Staff Report

To: Salt Lake City Planning Commission
From: Eric Daems, Senior Planner, eric.daems@slcgov.com, 801-535-7236
Date: May 24, 2023
Re: PLNPCM2022-00908, The Collaborative 1150

Design Review

PROPERTY ADDRESS: 1150 South Richards Street
PARCEL ID: 15-12-431-010-0000
MASTER PLAN: Central Community, Ballpark Station Area
ZONING DISTRICT: CC Corridor Commercial

1 East Elevation - HVA
3/32" = 1'-0"

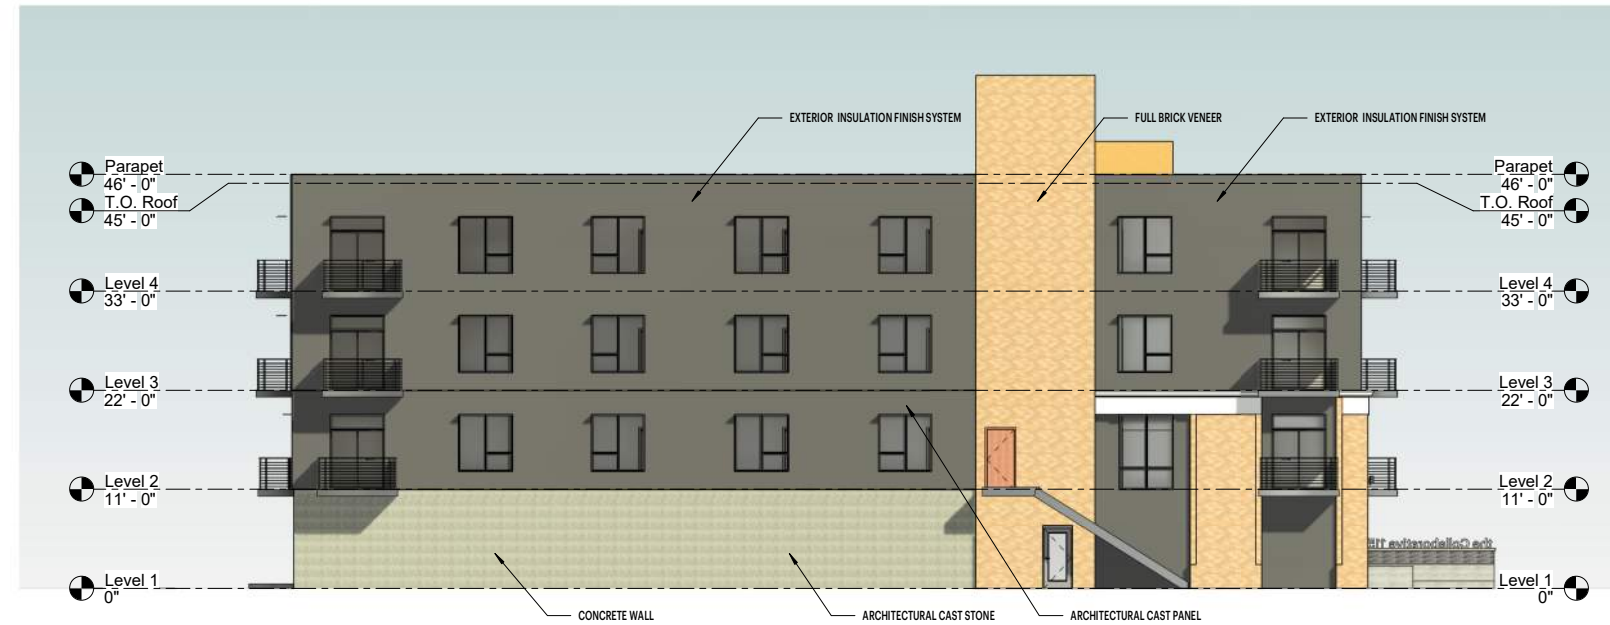
1. Please provide percentage of glass between 3-8' facing both Richards and Fremont Street
2. Building is longer than 200' (narrative states it is not)- no action needed, but this will be discussed as part of the Design Review.

this calculation is approx total glazing of Level 1
3-8' glazing along Richards Street
Building Length = 277'-6"
x Level 1 Height = 5'-0"
= 3,052 SF
(Level 1) Glazing % = 592/3,052 = 19.09%

this calculation is approx total glazing of Level 1
622 SF glazing along Richards Street
Building Length = 277'-6"
x Level 1 Height = 5'-0"
= 1,387 SF
(Level 1) Glazing % = 937/3,387 = 67.67%
